ECONOMISER ASSEMBLY

DRG NO : EC-01-GA-001

SAMPLE (SYNTHETIC) DRAWING

BOM CHECK SUMMARY

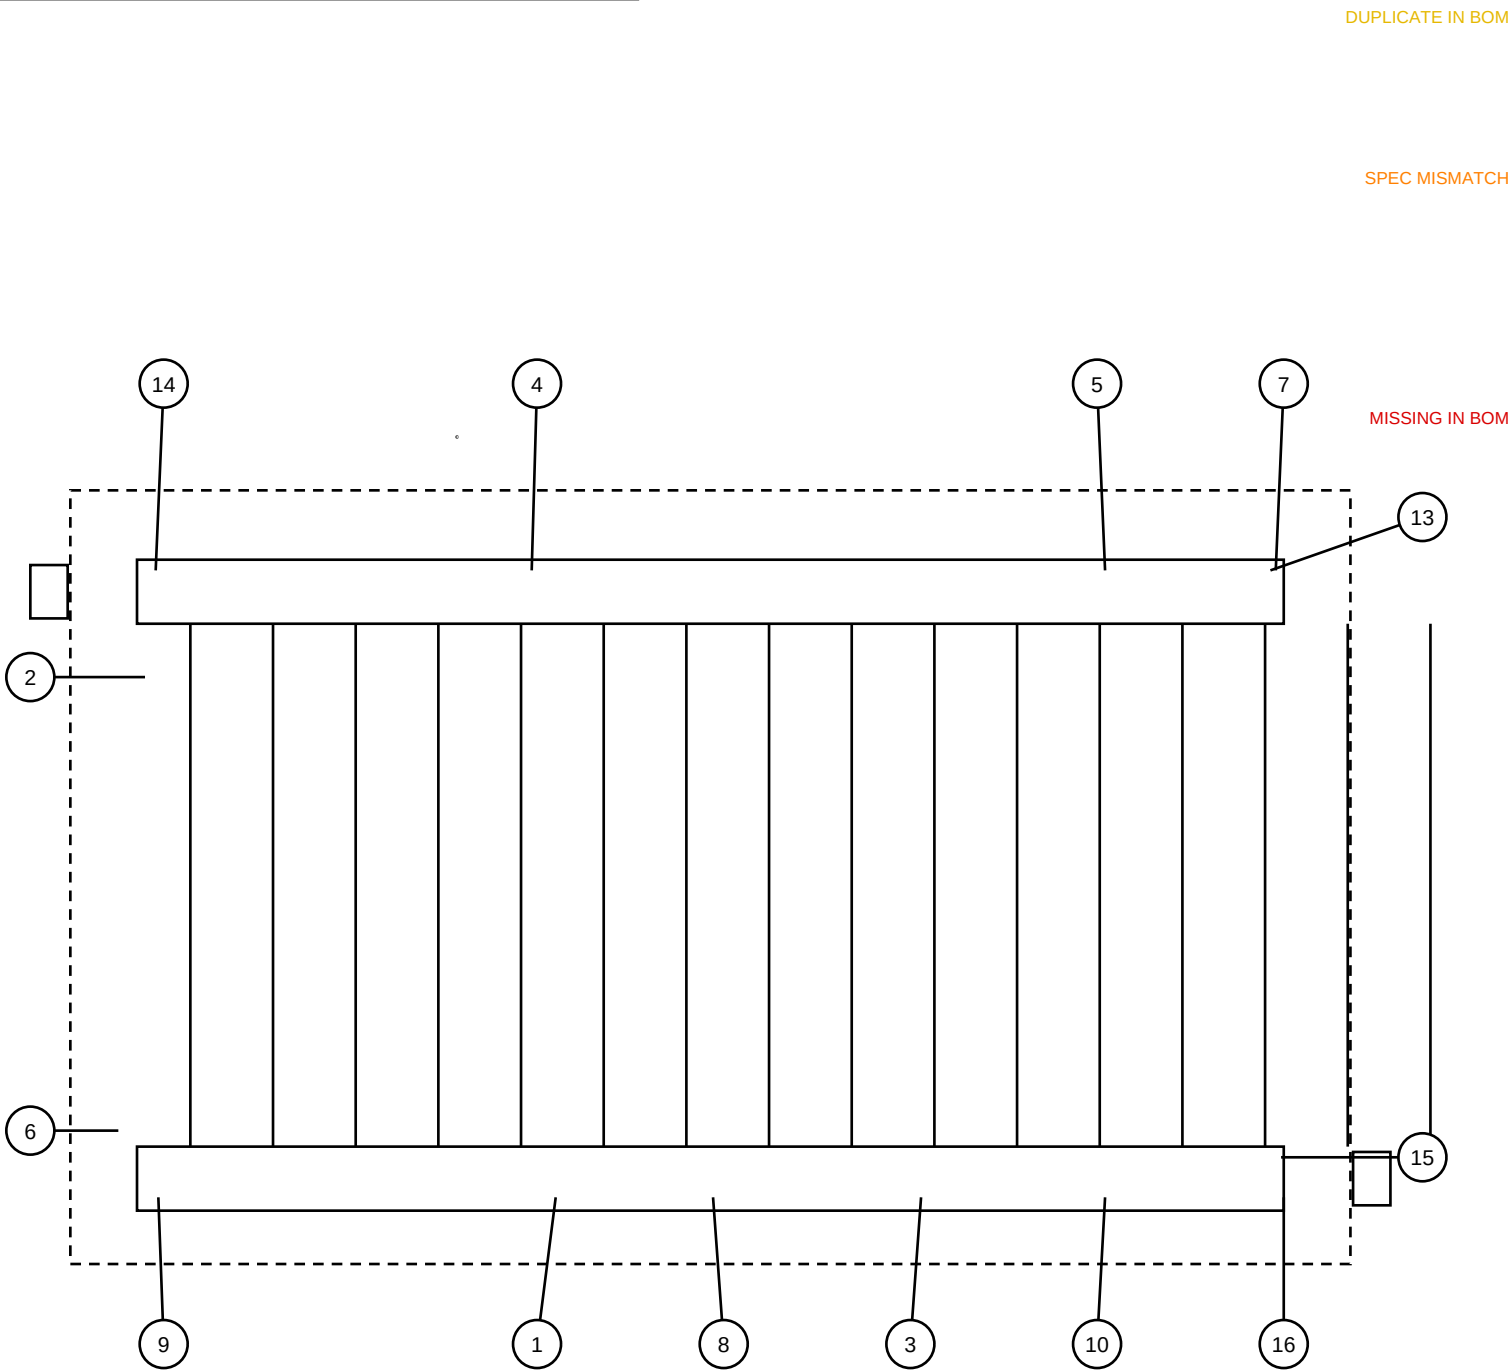
1. ALL DIMENSIONS ARE IN MM.
2. ALL WELDING AS PER IBR / ASME SEC I.
3. INSULATE WITH 100 THK MINERAL WOOL AND CLAD WITH 0.6 THK ALUMINIUM SHEET. <- BOM LACKS: Cladding

[RED] Item 12 'STUD BOLT M20 X 90 WITH 2 NUTS' (qty 16) is on the drawing but has no BOM line
[ORANGE] Item 6: specification mismatch - dimension: drawing ['200'] vs BOM ['250']
[YELLOW] BOM row 23 'Outlet header 219.1 OD x 8 thk' repeats item 2 (already covered by BOM row 7)
[BLUE] Suggestion (Cladding): the drawing notes imply it, but no matching line was found in the BOM
